Feasibility Study

**Wendover Avenue (SR1541)
From Sapp Road To NC. 68
Guilford County**

**Prepared By
Thoroughfare Planning Unit
Planning and Research Branch
Division of Highways
N.C. Department of Transportation**

ADDENDA

SIX LANES DIVIDED WITH GRASS MEDIAN — URBAN

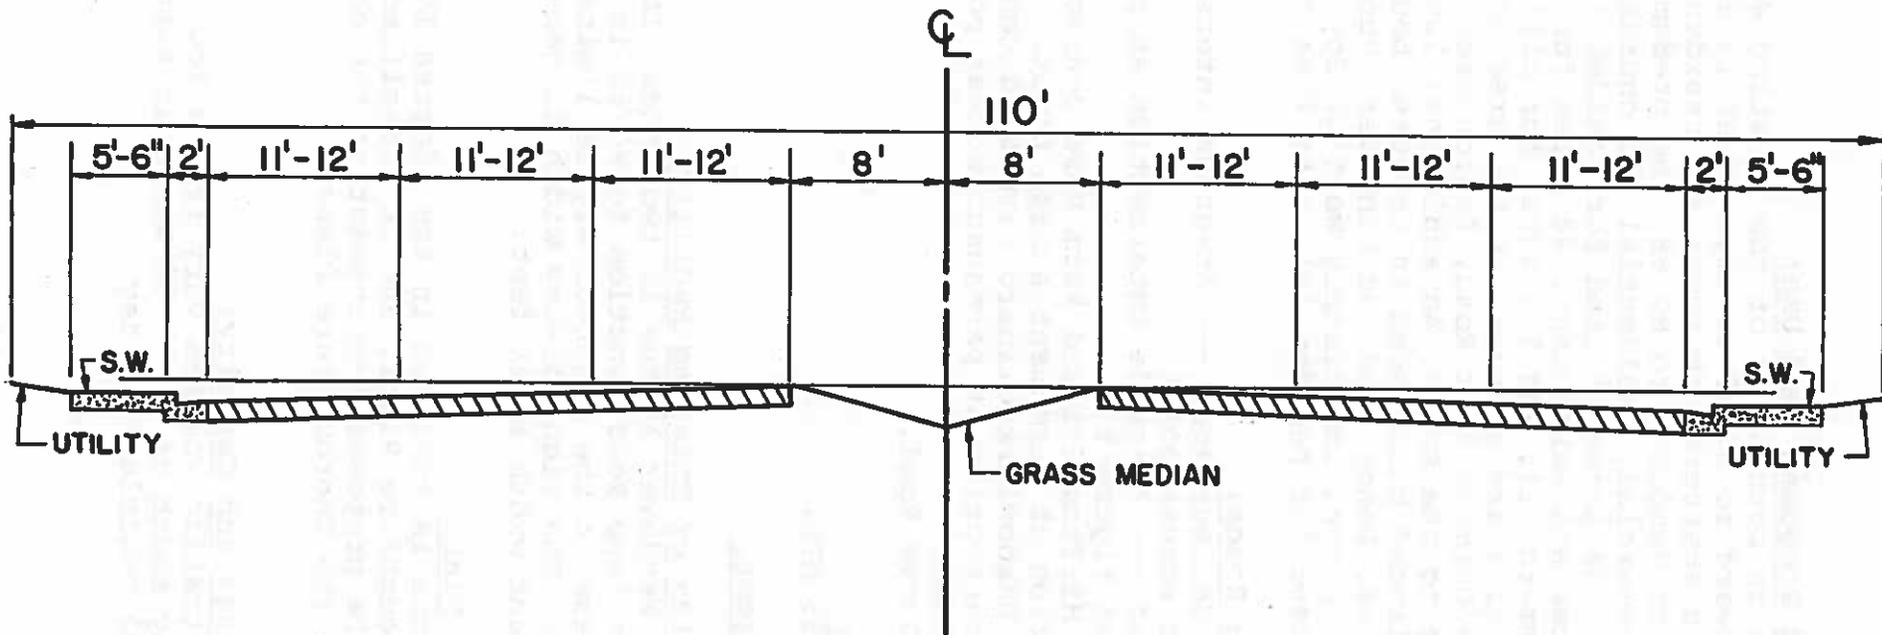
Re: Proposed Thoroughfare Cross Section

The thoroughfare cross section, as reported in this preliminary studies report shows a 16-foot median. 16' median will be adequate only for berm type (raised median) construction. Swale (Ditch) type median needs 26' minimum + 2' paved inside shoulders (30' total). This extra width also provides for double left lanes when and where needed. Therefore, if a grass median construction is desired, a minimum of 124' right-of-way should be anticipated.
